REPORT SUMMARY

REFERENCE NO - 21/502853/LDCEX

Lawful development certificate (existing) for conversion of loft into habitable space, with hip to gable roof alterations and insertion of a rear dormer and 4no. front rooflights.

ADDRESS 3-5 Bower Place Maidstone Kent ME16 8BG

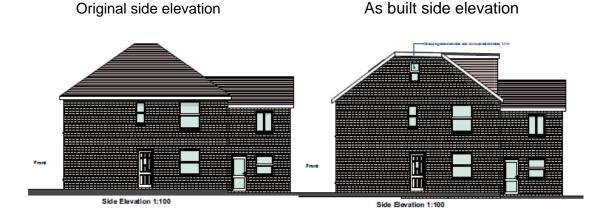
The application is not accompanied by any schedule of how the works were carried out, however the submitted plans in themselves clearly indicate that the roof form has been altered. The plans suggest that there has been a decrease in height and the original flat ridge has been extended and flattened further. I would question the accuracy of the plans as the as built elevations indicate the rear dormer to be flush with the new ridge but it actually sits below the as built ridge height. (see extract plans and photographs below)
